SUNSET VILLAGE FILING NO. 4

CONSTRUCTION PLANS

**CONSTRUCTION DRAWINGS AMENDMENT,
DATED APRIL 4, 2026 BY ENGINEERING LOCAL
XPRTS, LLC.**

MODIFIED FOR S.I.A. CD SET
RICHARD D. LYON, PE
ATWELL, LLC
DECEMBER, 2021
EPC PROJ.: CDR-21-008

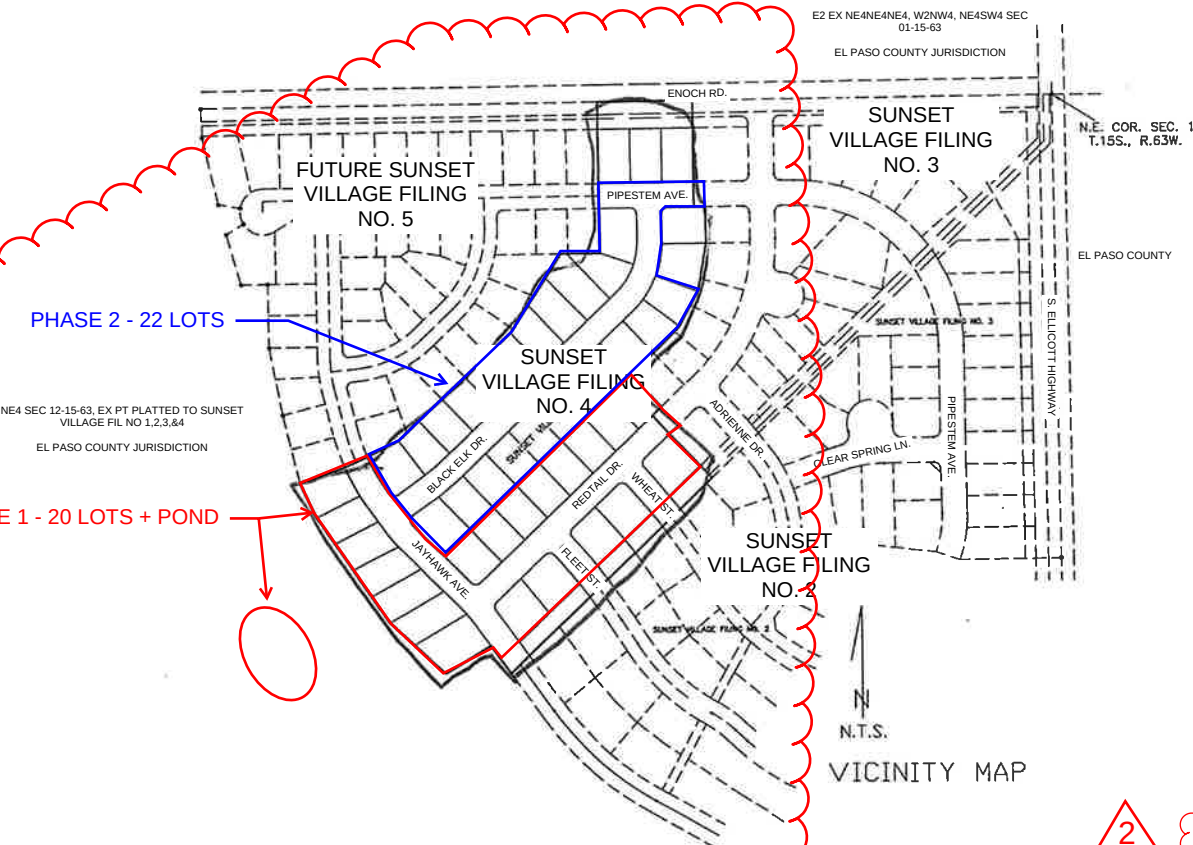
Per the County Attorney's Office, a Condition of Approval will be included with the Construction Plans.

Approval will be limited to Phase 1 improvements only.

The Construction Plans will need to be resubmitted for review/approval once the Developer intends to proceed with Phase 2.

Financial Assurances for Phase 2 improvements will be required at that time.

**POND OUTLET STRUCTURE
(PLAN VIEW)**
SCALE: 1" = 1-1/4'

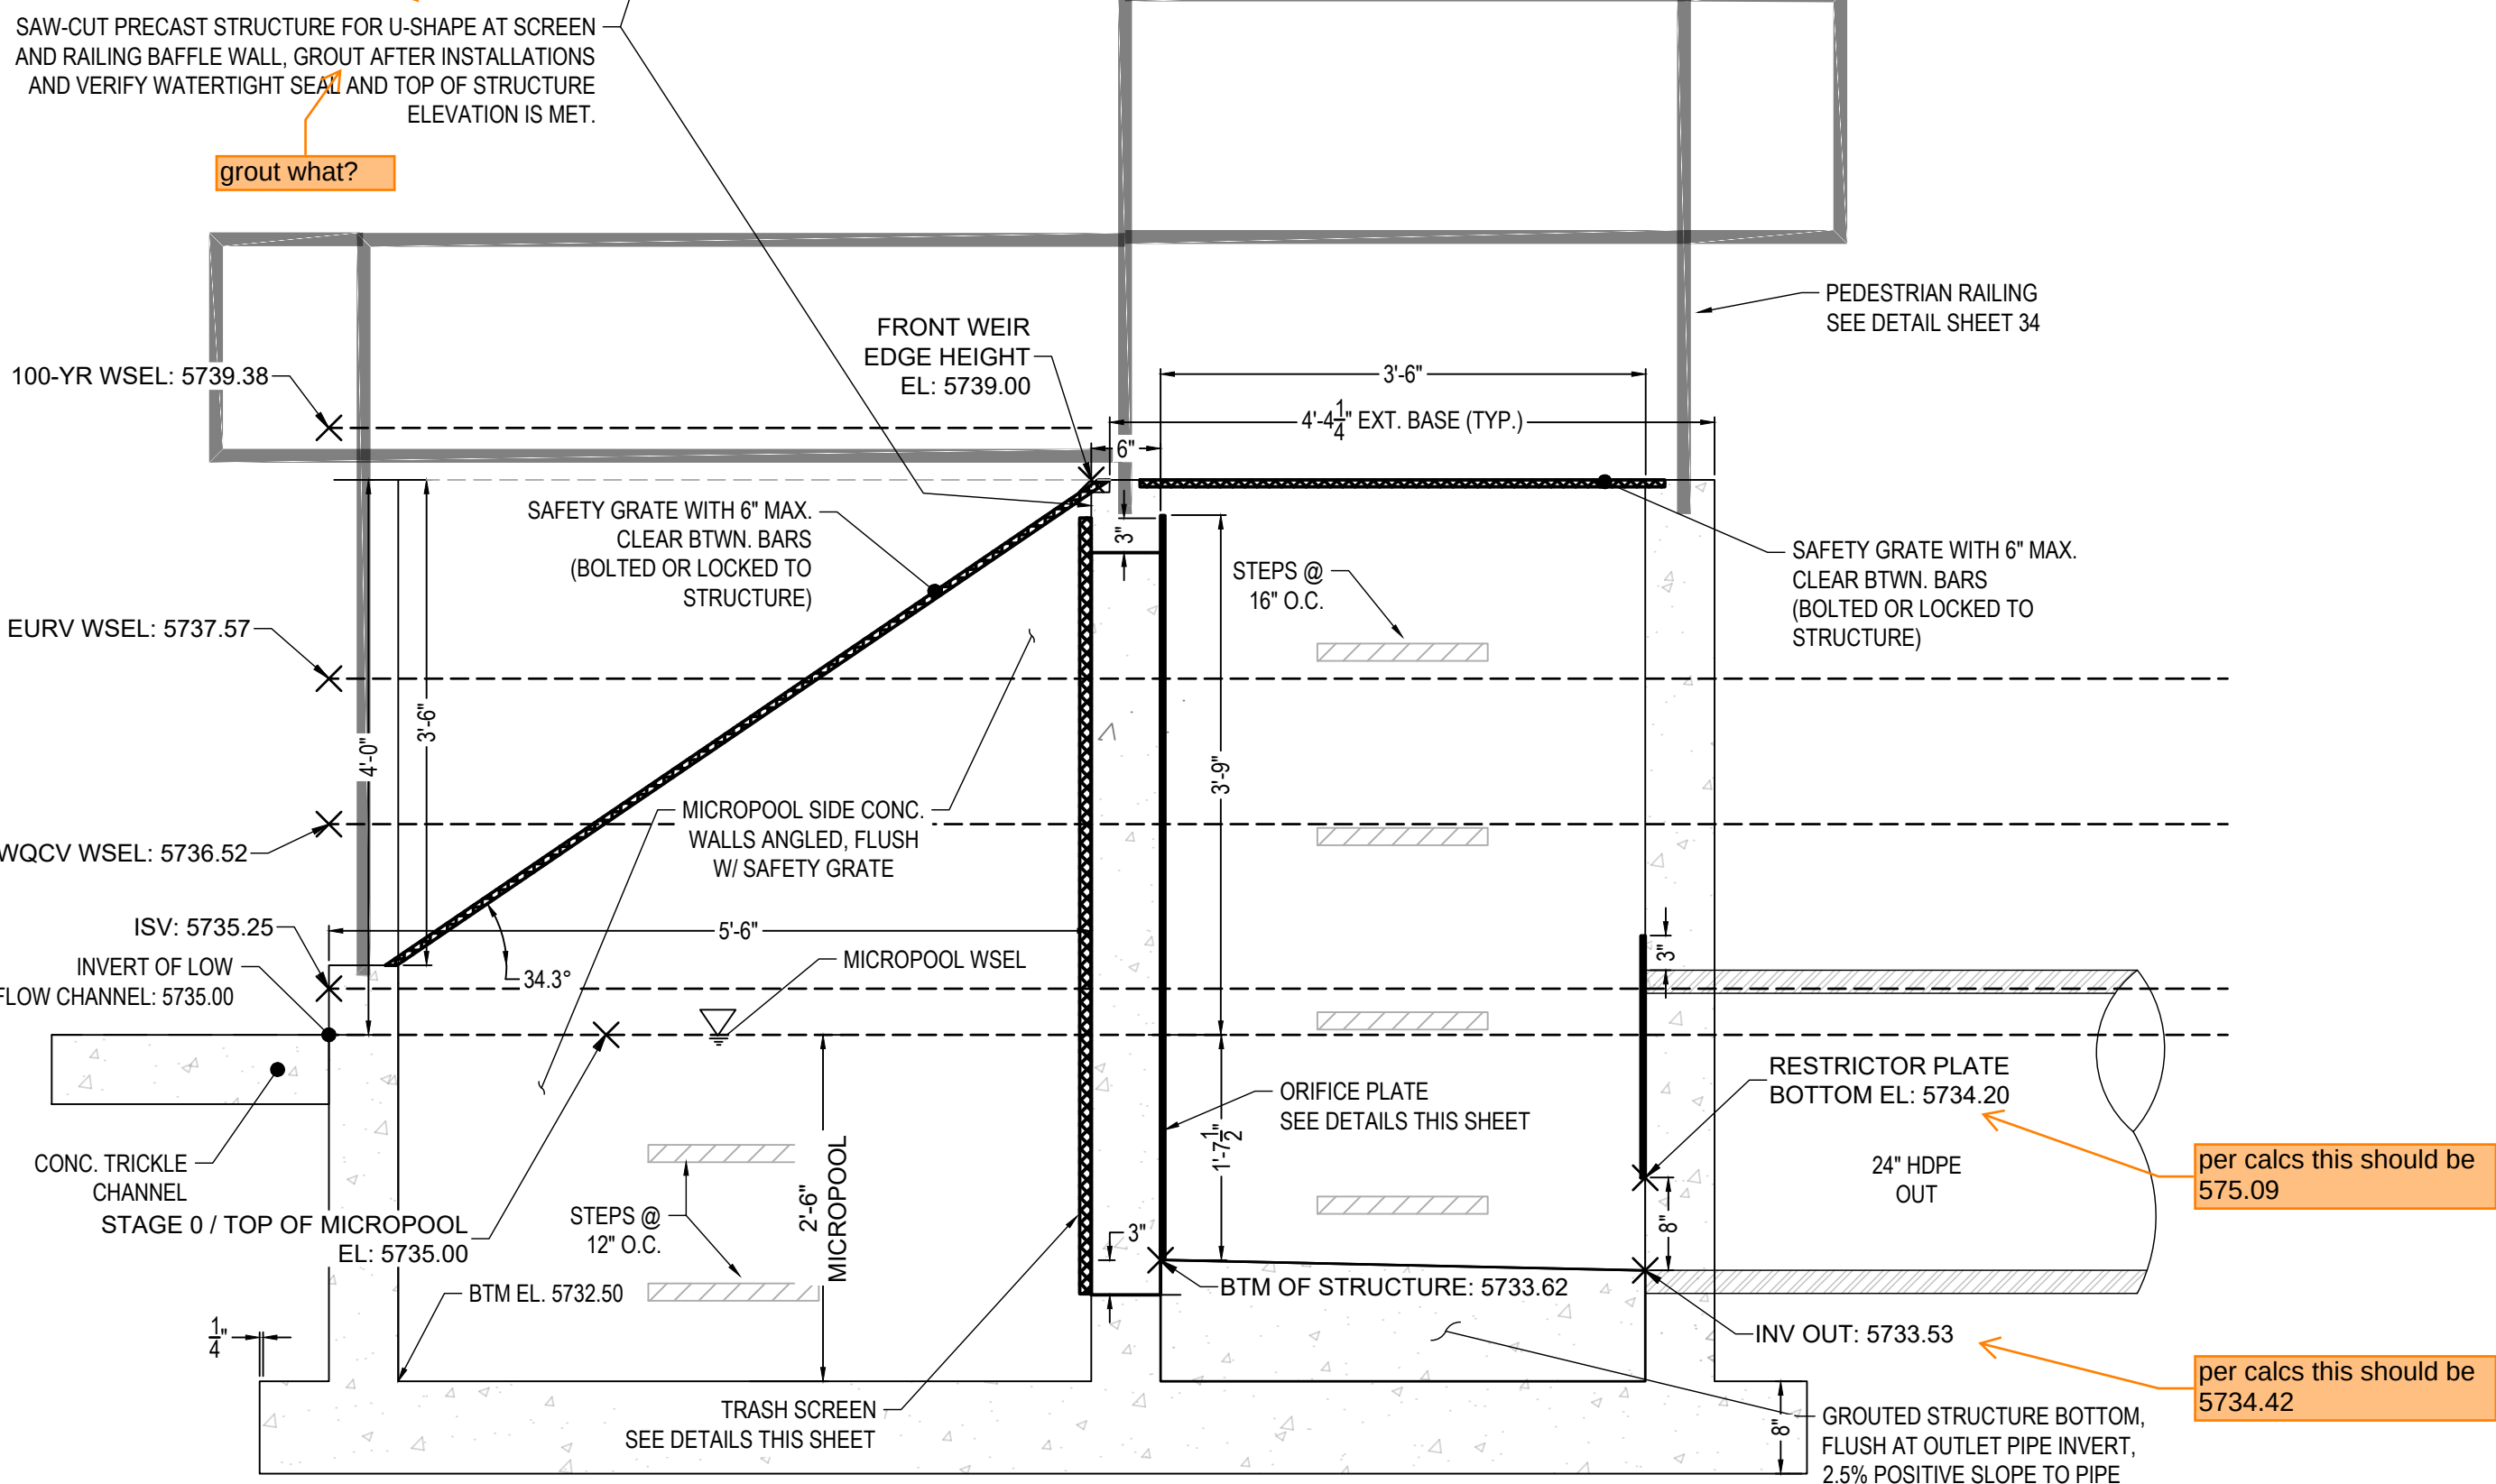
I might be misunderstanding your new note here, but if you are directing the contractor to create a u-shape, then there will be a gap at the top where debris can fall between the microscreen and orifice plate, bypassing the microscreen and clogging the orifice plate (plus it's very difficult to remove debris from that small area), which is obviously not desirable. So if you want the u-shape, you'll need to add that a metal plate should be added to the top to "close the U."
